Access Compliance Report

Public Rights-of-Way

Intersection ID: 48280	Main Street: KELSEY_WOODS_CT	Cross Street: ROBINWOOD_DR	Location: NE
ADA ID: 8E5D89A80C4B	Ramp Type: Perpendicular Diagonal	Initial Pass/Fail: Fail	Overall Compliance: No
		Severity Score: 12.5

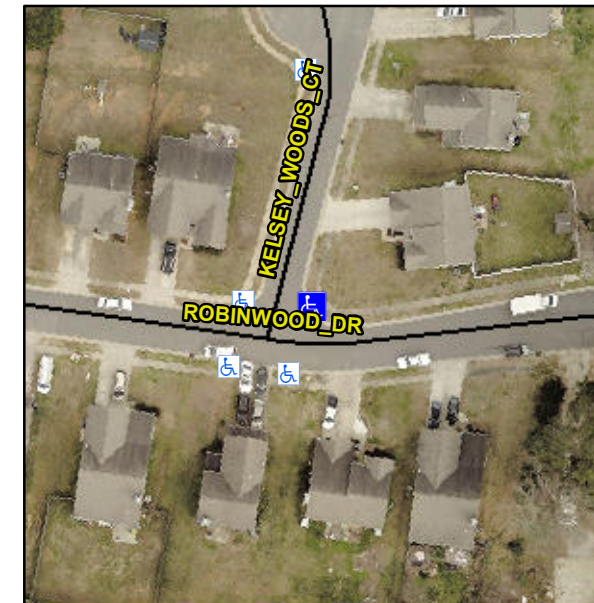
Not Found, R304.2.2

Compliance	Description	Data	Compliance	Description	Data
N/A	Ramp Length (in)	46.0	No	Ramp Slope (%)	8.9
Yes	Ramp Width (in)	48.0	Yes	Ramp XSlope (%)	0.9
N/A	Flare Type LT	N/A	N/A	Flare Type RT	N/A
N/A	Flare Slope LT (%)	N/A	N/A	Flare Slope RT (%)	N/A
N/A	Flare Traversable LT?	N/A	N/A	Flare Traversable RT?	N/A
N/A	Landing Length (in)	N/A	N/A	DWS Provided?	N/A
N/A	Landing Width (in)	N/A	N/A	DWS Contrast?	N/A
N/A	Landing Slope (%)	N/A	N/A	DWS Length (in)	N/A
N/A	Landing X Slope (%)	N/A	N/A	DWS Full Width?	N/A
N/A	Landing Curb? (Y/N)	N/A	N/A	DWS Offset (in)	N/A
N/A	Shared Landing?	N/A			
N/A	Gutter Ponding?	N/A	N/A	Gutter Slope (%)	N/A
N/A	Gutter Lip Ht (in)	N/A	N/A	Gutter X Slope (%)	N/A
N/A	Painted X Walk1?	No	N/A	Painted X Walk2?	No
	X Walk 1 Direction	To W		X Walk 2 Direction	To S
N/A	X Walk 1 Width (in)	N/A	N/A	X Walk 2 Width (in)	N/A
	X Walk 1 Slope (%)	2.1		X Walk 2 Slope (%)	1.7
	X Walk 1 X Slope (%)	2.0		X Walk 2 X Slope (%)	1.9

Remove & Replace Curb Ramp With Two New Directional Ramps or Equivalent.
